CH6, Sec3, 3.2.4 – Checking criteria

Rule Change:

Figure 1: interaction **without** the requirement that the plate has to be stiff enough to withstand each compressive stress alone

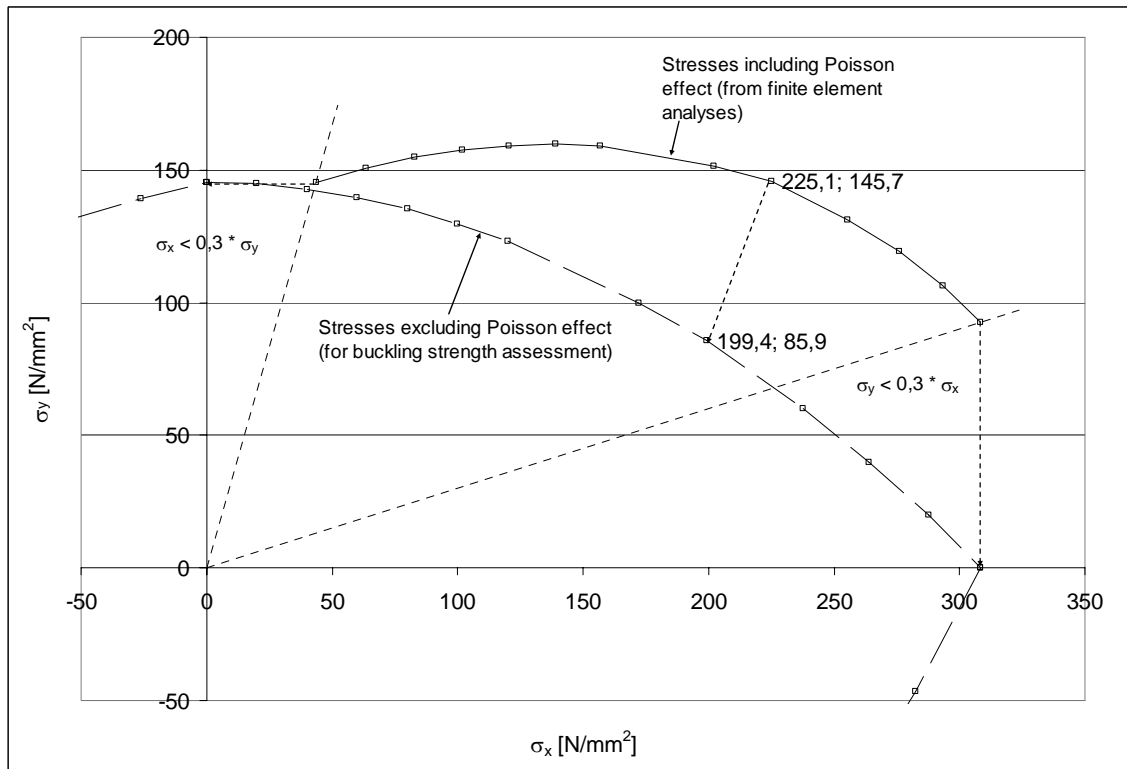
In addition each compressive stress σ_x and σ_y and the shear stress τ are to comply with the following formulae:

$$\left(\frac{\sigma_x \cdot S}{K_x \cdot R_{eH}} \right)^{e1} \leq 1.0$$

$$\left(\frac{\sigma_y \cdot S}{K_y \cdot R_{eH}} \right)^{e2} \leq 1.0$$

$$\left(\frac{|\tau| \cdot S \cdot \sqrt{3}}{K_\tau \cdot R_{eH}} \right)^{e3} \leq 1.0$$

GL-Answer: In General we consider only the rule defined load cases and loading conditions for the dimensioning of the structure, which are called design-load cases. In case of buckling checks we have to accept, that in reality also load cases exist, they give other load and therefore stress combinations as defined in the design-load-cases. Of course it is guaranteed, that the design-load cases cover the cases with respect of the calculation of the most critical stress-components. In case of buckling we have to consider all possible stress combinations. This is somewhat different and because of that we require, that the buckling strength of the plate has to be high enough to withstand each compressive stress acting alone. This means, that possible stabilizing effects of pressure stresses are neglected.

In Figure 1 the interaction curve is shown including the Poisson effect. As can be seen there are stress combinations allowable for which the σ_y -component can be greater, than in the case for σ_y is acting alone on the plate. Because of the problem mentioned above, the interaction curve as the base for the rule requirements is limited to stress combinations as shown in figure 2. Please note that this figure is given in Appendix 1 of the Buckling-TB-document. Please refer to “Buckling Strength Assessment of Plates in the IACS Common Structural rules for Bulk Carriers – Sample Applications” , Figure 2.
